HEARING DATE: June 4, 2024
 TO: Mayor & City Council
 FROM: Sonya Allen, Associate Planner
 208-884-5533
 SUBJECT: Pebblebrook Subdivision – AZ, PP
[H-2024-0005](#)
 LOCATION: 5725 N. Meridian Rd., in the NE 1/4 of
 Section 25, T.4N., R.1W. (Parcels
 #S0425142030 & S0425141990)

Annexation of 13.94-acres of land with an R-8 zoning district; and Preliminary Plat consisting of 54 building lots and 6 common lots on 13.94-acres of land.

L1.5

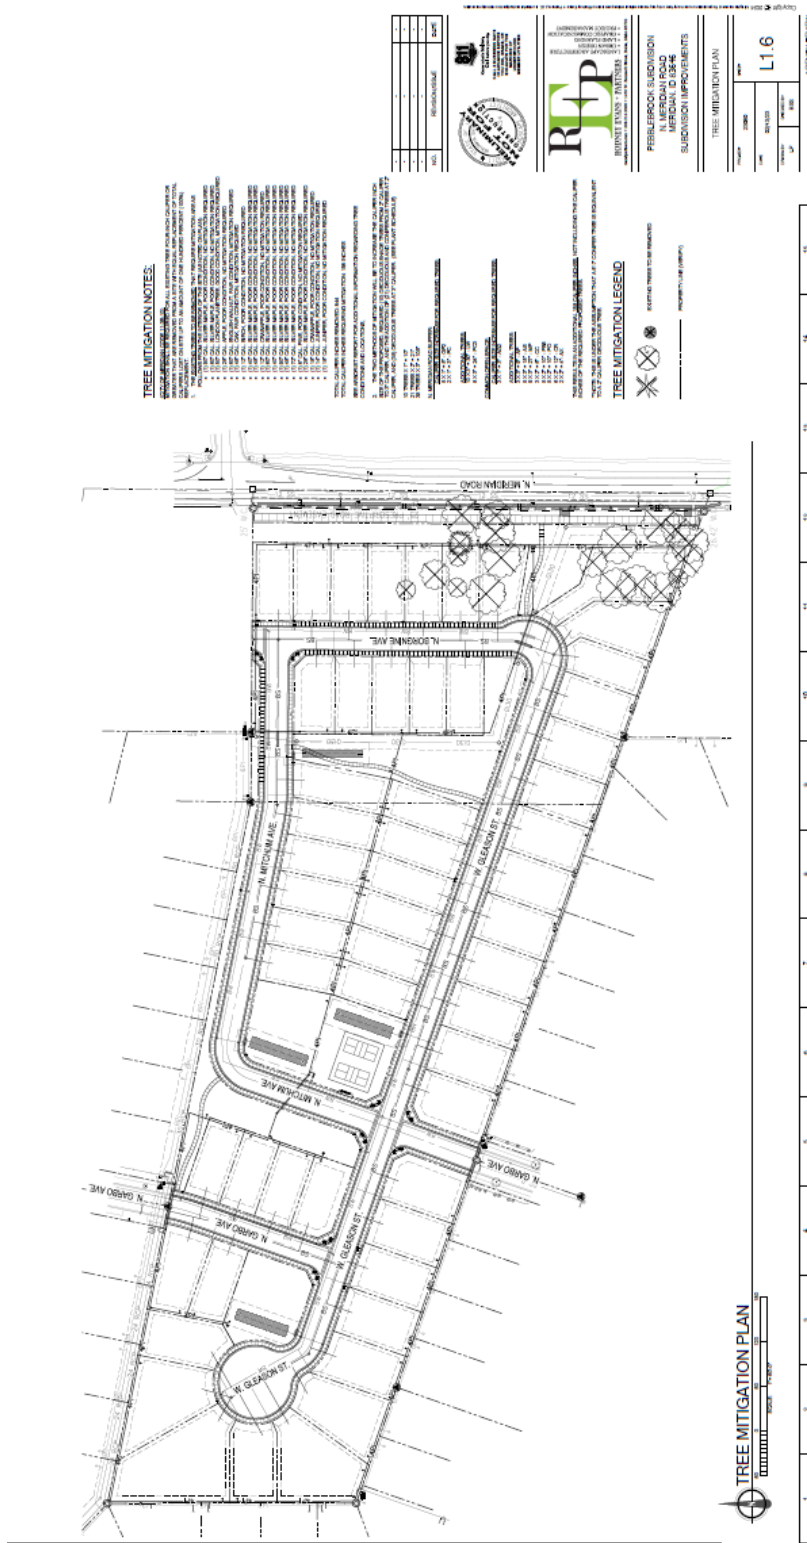
Landscaping is required to be provided within the buffer in accord with the standards listed in UDC [11-3B-7C.3](#), including the standards for entryway corridors. The proposed buffer incorporates a berm with a maximum 3:1 slope, a wrought-iron fence at the back edge of the buffer, landscaping and boulders within the planter areas in accord with these standards. **If the unimproved street right-of-way is ten (10) feet or greater from the edge of pavement to edge of sidewalk or property line, the developer is required to maintain a ten-foot compacted shoulder meeting the construction standards of the transportation authority and landscape the remainder with lawn or other vegetative ground cover; the landscape plan should be revised accordingly.**

The landscape plan depicts a 5' tall open vision wrought iron fence at the back edge of the street buffer along N. Meridian Rd. and adjacent to internal common open space areas; and a 6' tall cedar privacy fencing is proposed along the northern boundary of the site abutting the County parcel. **Fencing appears to be missing in some areas adjacent to common open space areas; fencing should be provided to distinguish common from private areas in accord with UDC [11-3A-7A.7a](#).**

3. The landscape plan submitted with the final plat application shall include the following revisions:
 - a. Depict lawn or other vegetative groundcover on the east side of the sidewalk along N. Meridian Rd. as set forth in UDC [11-3B-7C.5](#), which states, *"If the unimproved street right-of-way is ten (10) feet or greater from the edge of pavement to edge of sidewalk or property line, the developer is required to maintain a ten-foot compacted shoulder meeting the construction standards of the transportation authority and landscape the remainder with lawn or other vegetative ground cover."*

- b. Depict fencing abutting all pathways and common open space lots to distinguish common from private areas in accord with UDC [11-3A-7A.7a](#).
 4. All irrigation ditches crossing this site shall be piped or otherwise covered as set forth in UDC [11-3A-6B.3](#).

Tree Mitigation Plan:

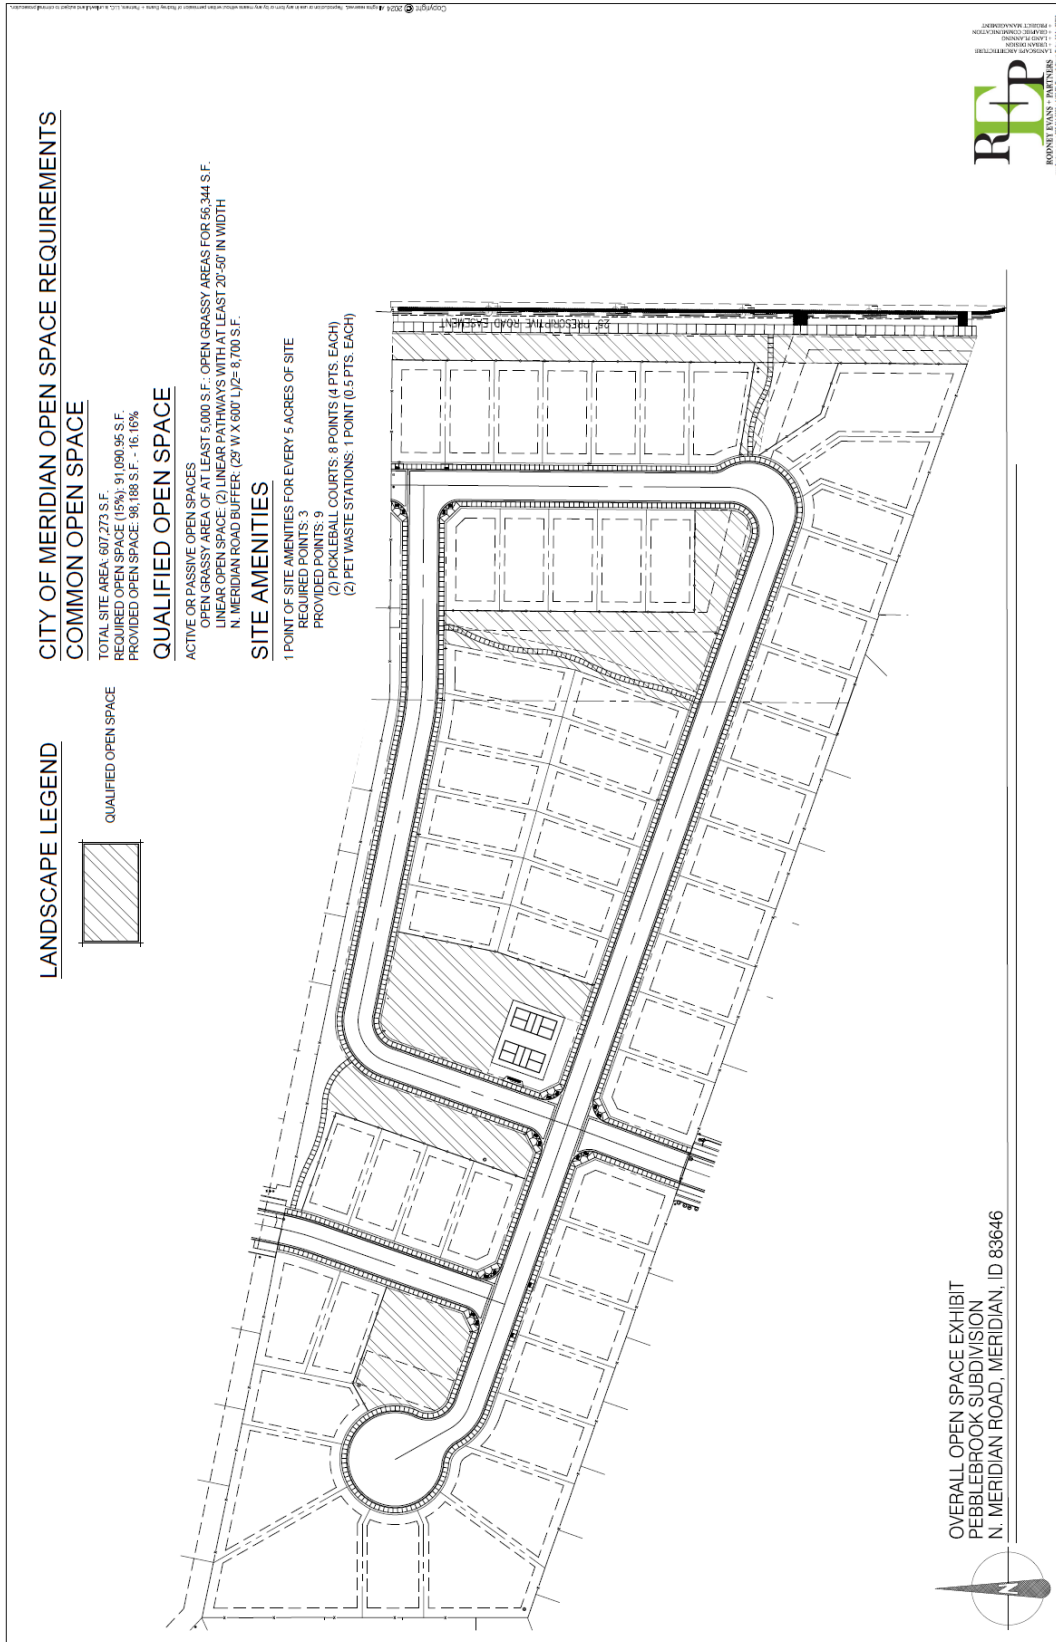
There are a lot of existing trees on the site, totaling 844 caliper inches, that are proposed to be removed as they were determined to be in poor condition by the Applicant's arborist (see [arborist report](#) and Sheet L1.6 of the landscape plan). The remaining trees, totaling 158 caliper inches, are required to

comply with the mitigation standards listed in UDC [11-3B-10C.5](#). Additional trees are proposed in accord with the required standards.

D. Common Open Space & Site Amenities Exhibit

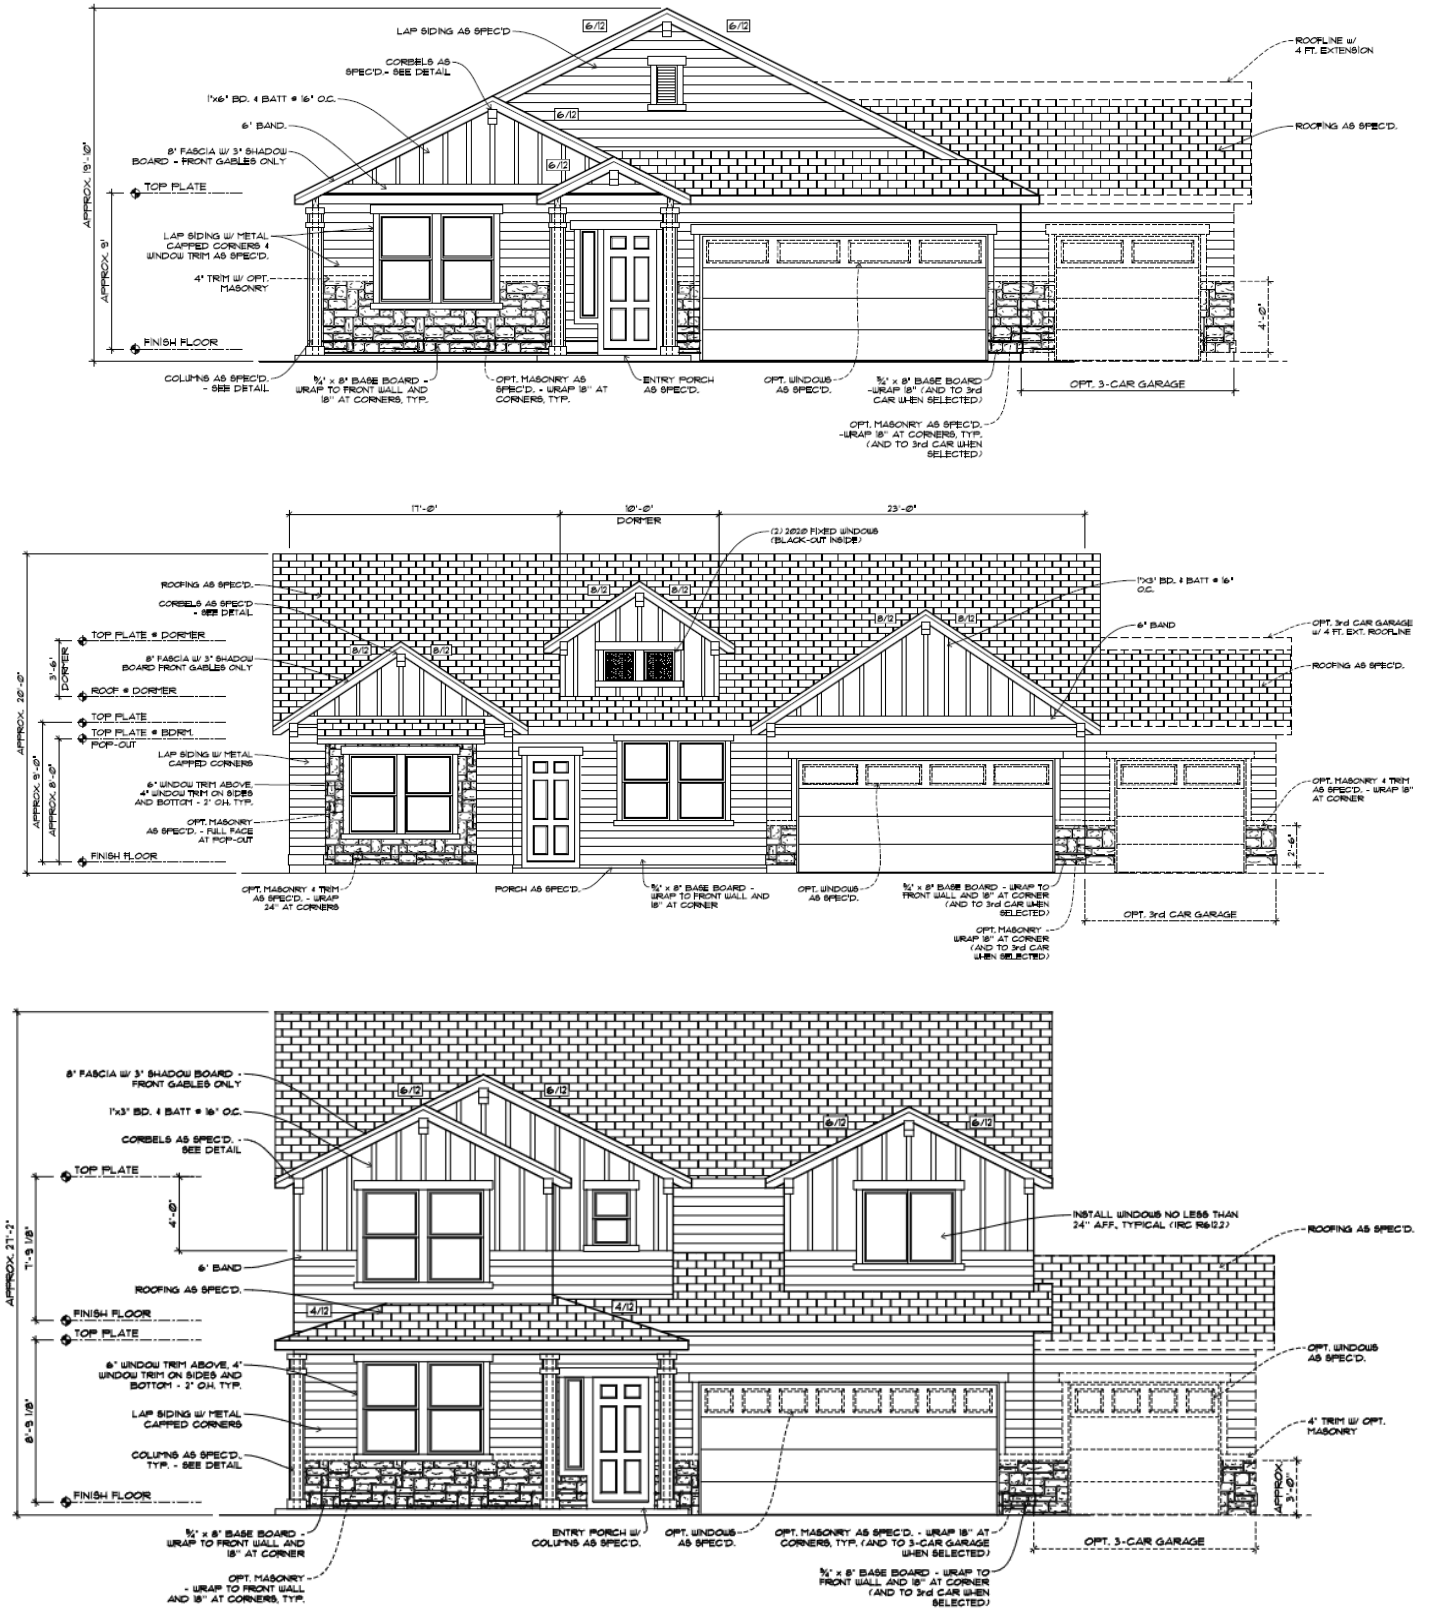
Common Open Space & Site Amenities (UDC [11-3G-3](#)): Based on the standards in UDC Table 11-3G-3, a minimum of 15% (or 2.09-acres) of qualified open space is required to be provided within the development. An open space exhibit was submitted as shown in Section VIII.D, that depicts 16.16% (or 2.25-acres) of open space that meets the required quality and qualified open space standards.

6. A minimum of 2.25-acres of qualified open space shall be provided within the development in accord with the open space exhibit included in Section VIII.D.
